S E R V I C E N O T E

8922E GSM MS Service Test Set

Serial Numbers: 3234A00101 / 3343A00150

Recommended Removal of Hardware

FIGURE 1
Top Internal View of HP 8922A/B/E/G

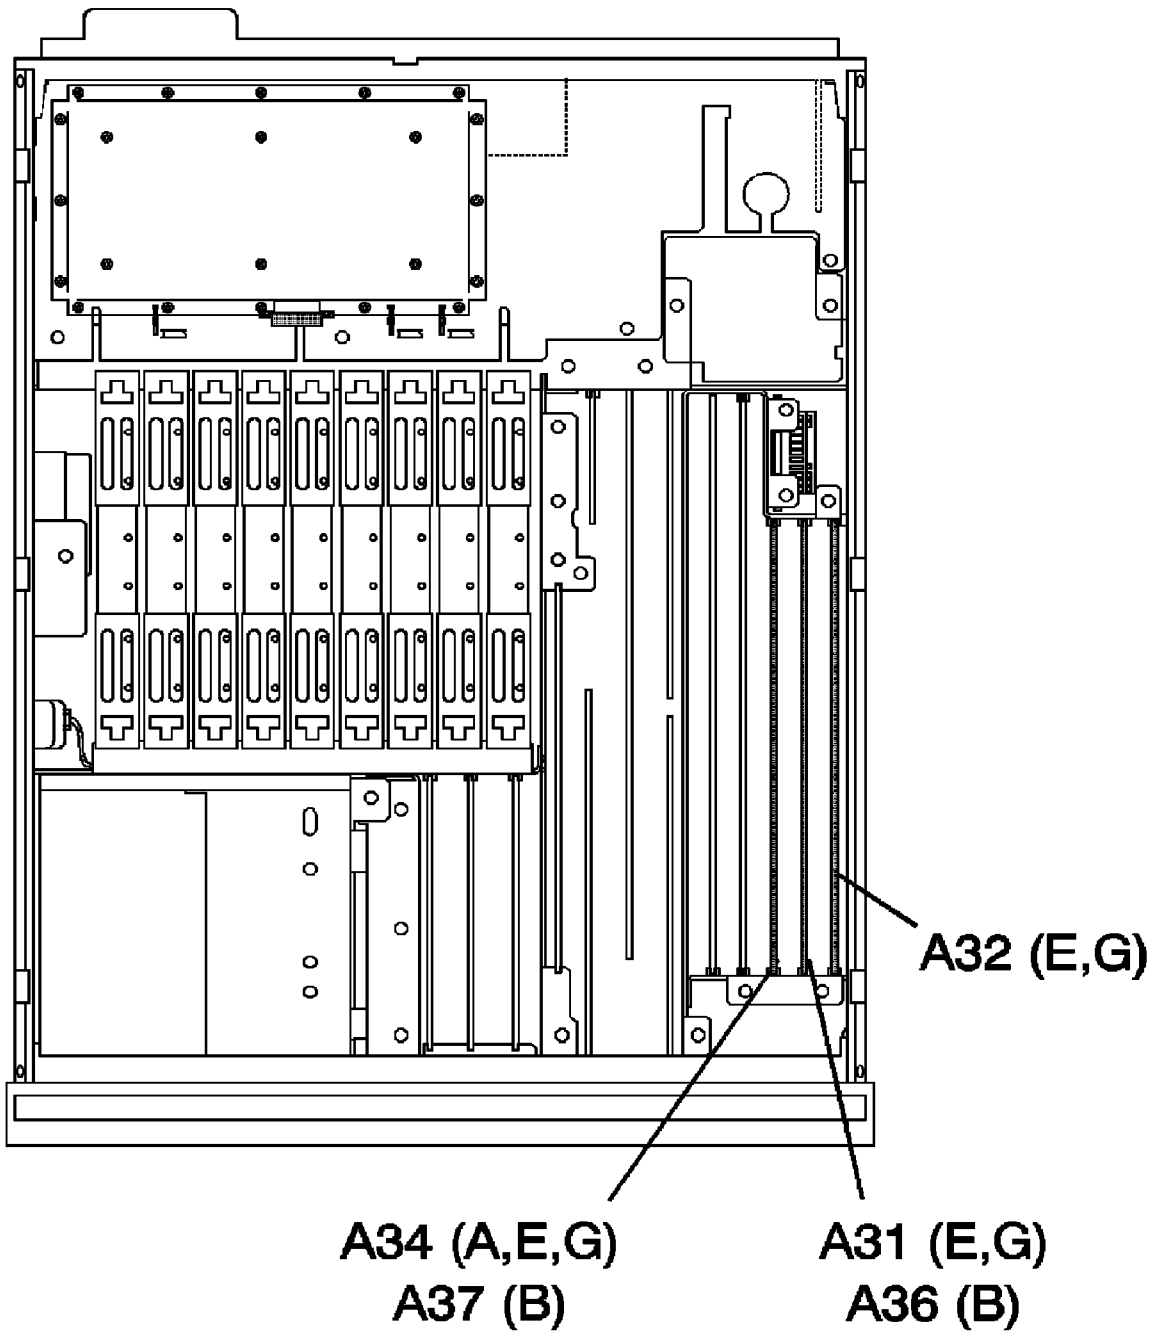
Instruments with serial numbers noted above may have internal hardware (screw and nut) which is improperly attached to the A31 GSM CODEC, A32 GSM Controller, and A34 GSM RTI assemblies. Refer to Figure 1 for location of these assemblies. The hardware can become separated from the assembly, contact other circuitry and may cause electrical damage.
